RESPONSES TO JULY 9, 1984 DNR COMMENTS ON THE NOISE REPORTS

EXXON MINERALS COMPANY
CRANDON PROJECT

OCTOBER 31, 1984

MASS OF EXPLOSIVES
PER DELAY

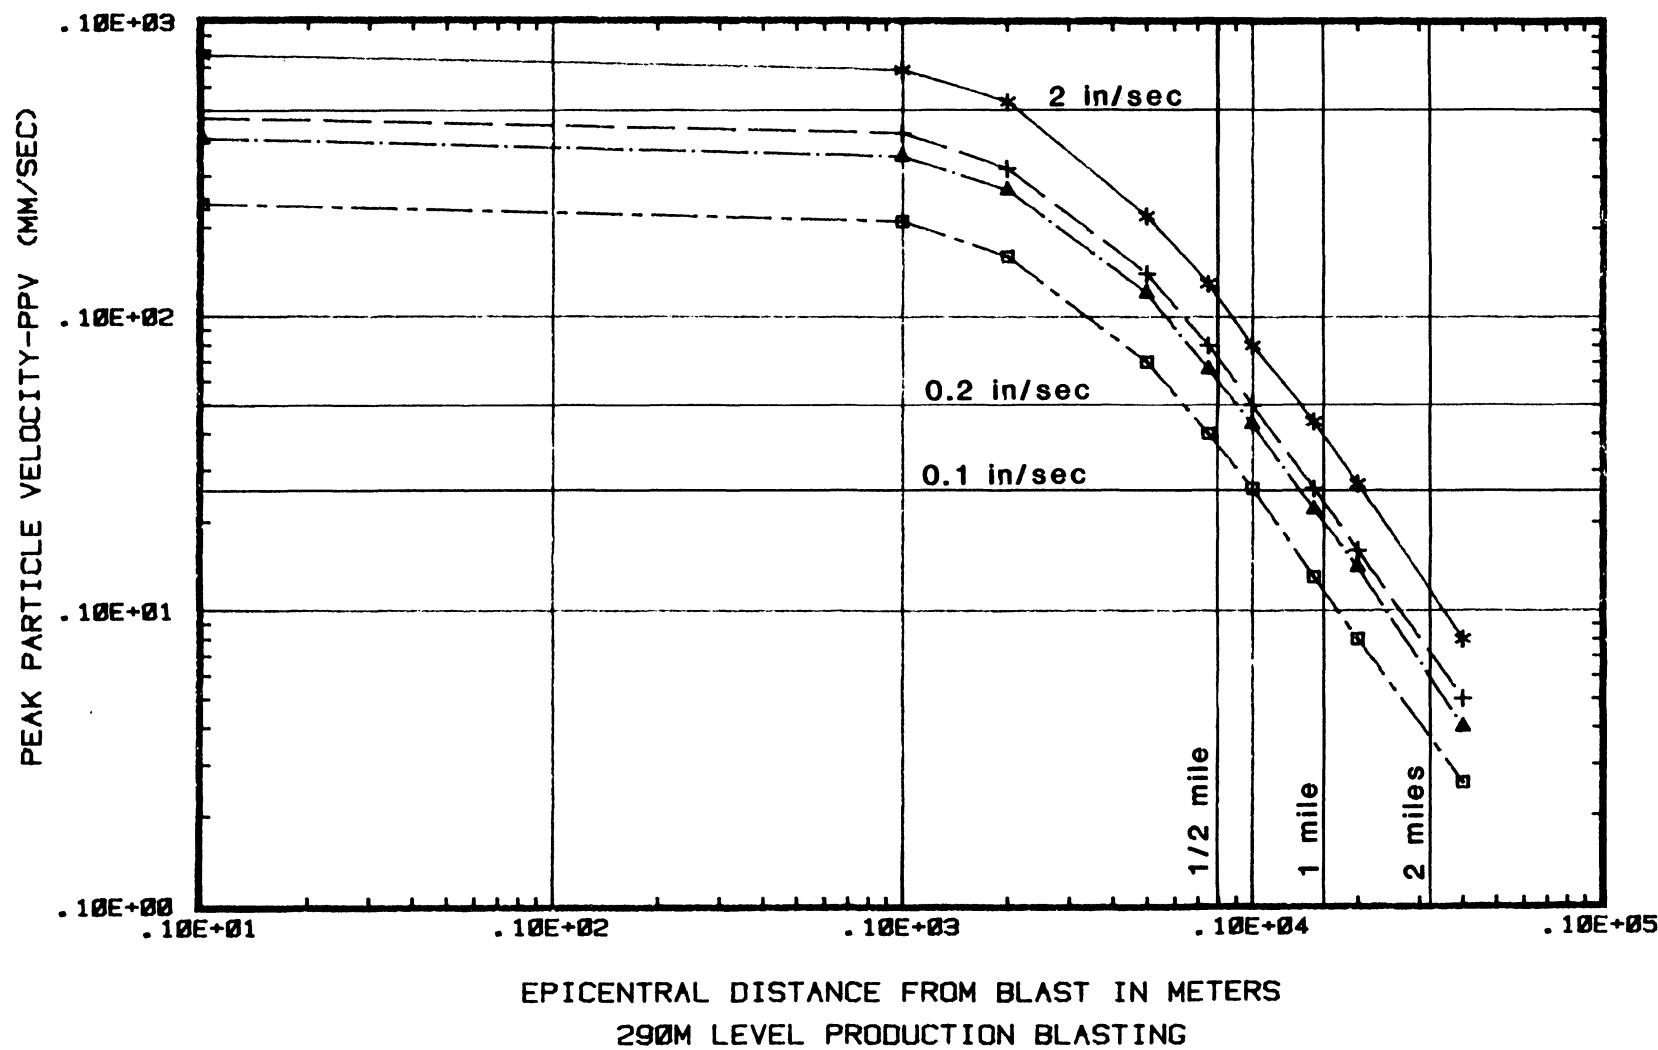
The analysis method is depicted on p. 61 of the October 31, 1984 responses. While the method is correct, its application is not. It is assumed that blast vibrations will travel in a straight line from the point of explosion to the ground level receptor. In fact, vibrations move a greater distance through the bedrock before traveling through the overburden. This causes surface vibrations to be greater than predicted using Exxon's approach. Since off-site vibrations were shown to be detectable, the analysis should be adjusted to account for this phenomenon. This subject is discussed further in "Vibrations of Soils and Foundations" by Ricardi.

The estimated ground surface peak particle velocities presented on Figures 2 through 9 in the response to comment No. 2 cover a wide range of cases for both blast depth and delay charge weight. Actual mine development or production blast design during operations will be such that the safety of mine surface facilities will be insured. With this in mind, blast design will limit PPV directly over the mine site to less than 50.8 mm/s (2.0 inches/second). As indicated on Figures 2 through 9, the calculated site responses for some of the delay sizes evaluated would result in PPV in excess of the imposed limit of 50.8 mm/s (2.0 inches/second). For the conditions assumed in predicting site response, higher delay charge weights would be unacceptable and not used for an underground blast.

Using the 50.8 mm/s (2.0 inches/second) as a limiting threshold, blast designs producing PPVs directly above the blast exceeding this threshold are meaningless. For acceptably designed blasts/delay, using the 50.8 mm/s (2.0 inches/second) design criteria, PPVs at a radius of 805 m (0.5 mile) or greater are generally less than 5.1 mm/s (0.2 inches/second) (Figures 2 through 9) or in the range defined on attached Figure 1 as between detectable and barely detectable. At a distance of 1,610 m (1 mile), predicted PPVs are below the barely detectable level of 2.5 mm/s (0.1 inches/second).

Curves have been replotted showing recalculated PPVs on both linear and log-log formats (see Figures 2 through 9 in the response to comment No. 2).

(FIGURE 1 FOR THE RESPONSE TO COMMENT NO. 3)

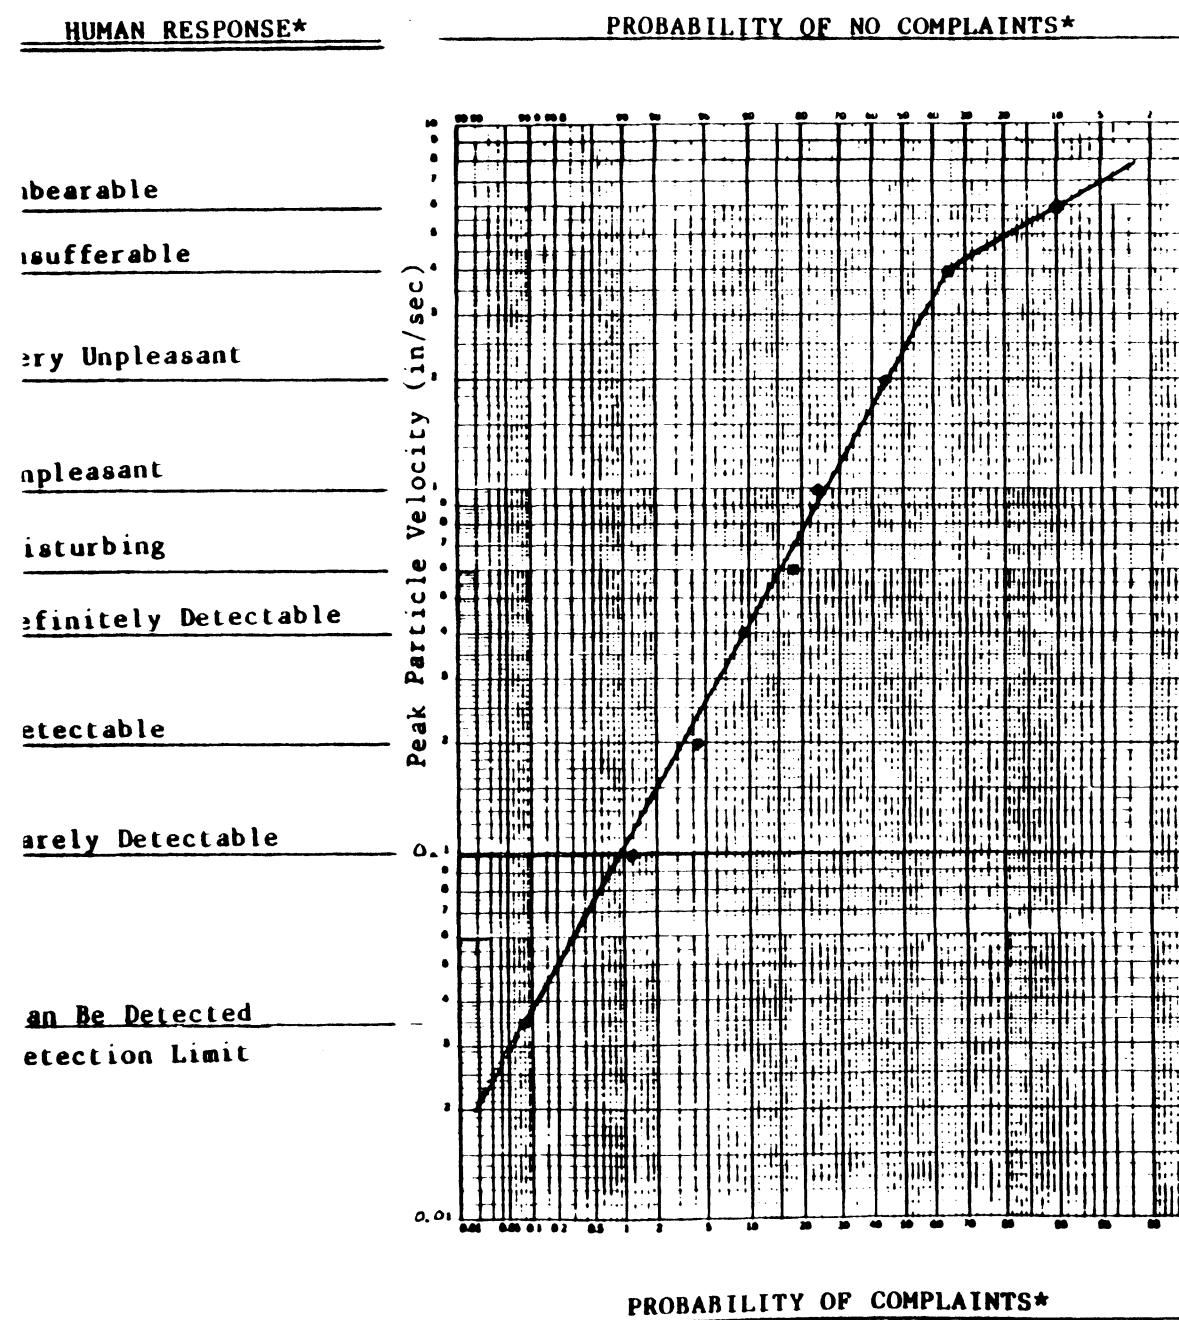
The analysis predicted blasting vibrations within 1/2 mile from the point of the blast. At 2,500 feet from the surface point above the blast, vibrations were predicted to be 0.14 to 0.26 inches per sec (peak particle velocity). This is well above the detection limit of 0.035 in/sec shown in Figure No. 8 on p. 70. Exxon should extend the analysis to a distance where blast vibrations are still detectable, as this may include nearby residences.

The calculated PPVs presented herein are theoretical using assumed site response parameters. Blast performance monitoring will be conducted during early site development associated with shaft sinking and early mining activities in order to allow the formulation of site specific response parameters. Design of actual production blasts will be based on the actual field data while maintaining the 50.8 mm/s (2.0 inches/second)

(FIGURE 1 FOR THE RESPONSE TO COMMENT NO. 7)

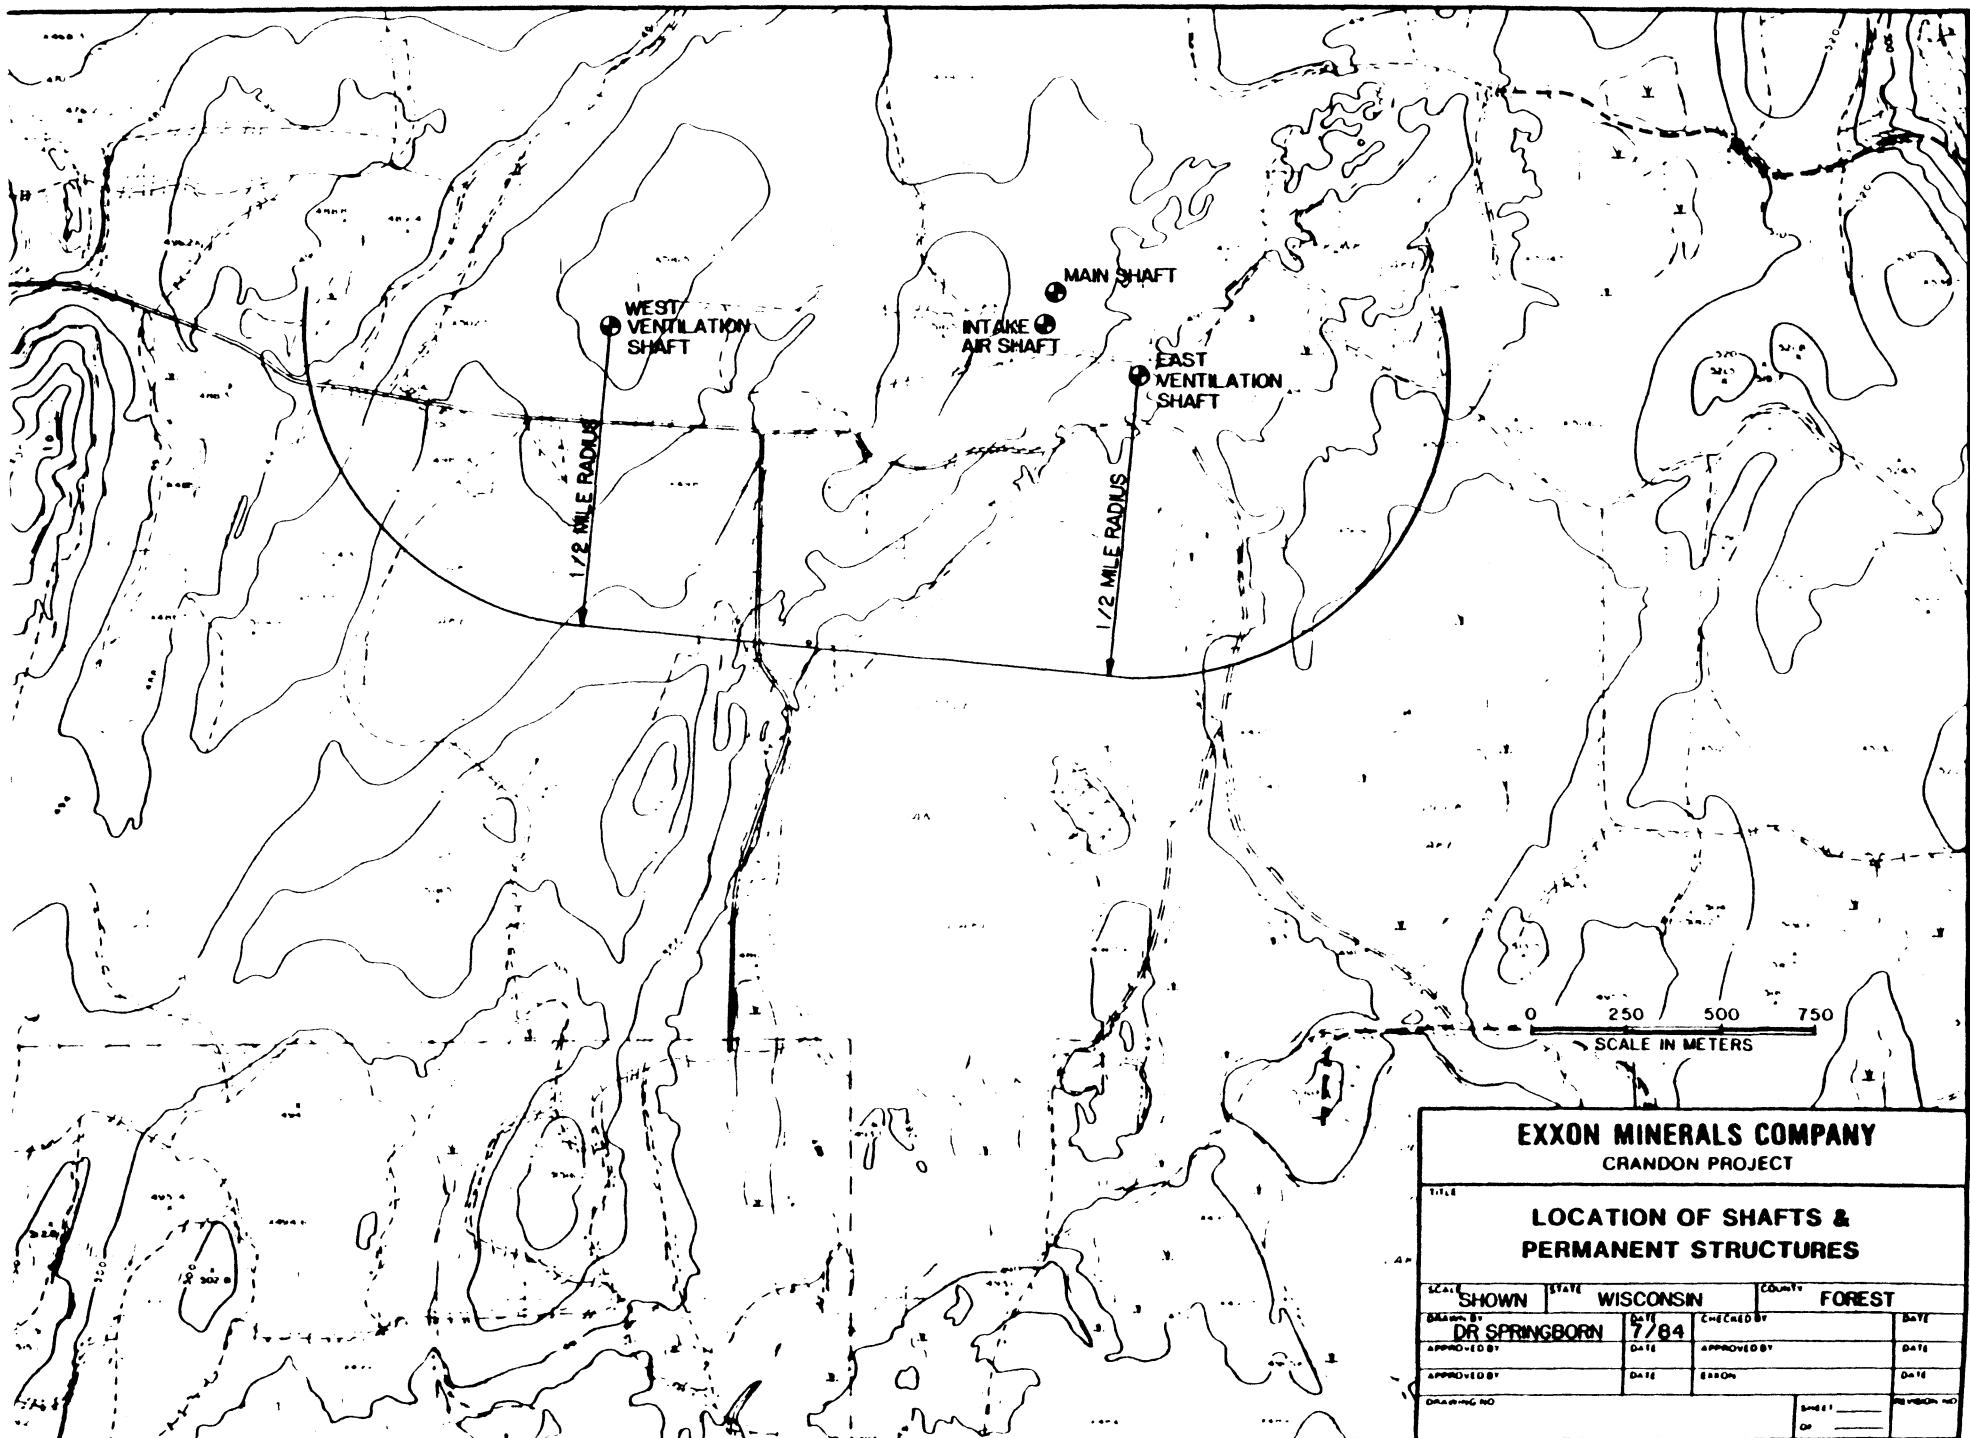
Has a plan been developed for monitoring surface level vibrations when blasting begins? If so, this should be submitted. Otherwise, a blast vibration monitoring plan should be developed.

Site blast monitoring will be limited to verification of design parameters during initial construction and mine operation events. Modern blasting agents and delayed initiation techniques will be employed as required by site conditions to control blast vibration and overpressure. All blasts will be designed to preclude damaging seismic, air blast, or noise effects immediately adjacent to all four mine openings to the surface (see attached Figure 1). Such protection of site personnel and physical facilities implies that off-site blast effects will be well below annoyance levels, if not totally imperceptible.
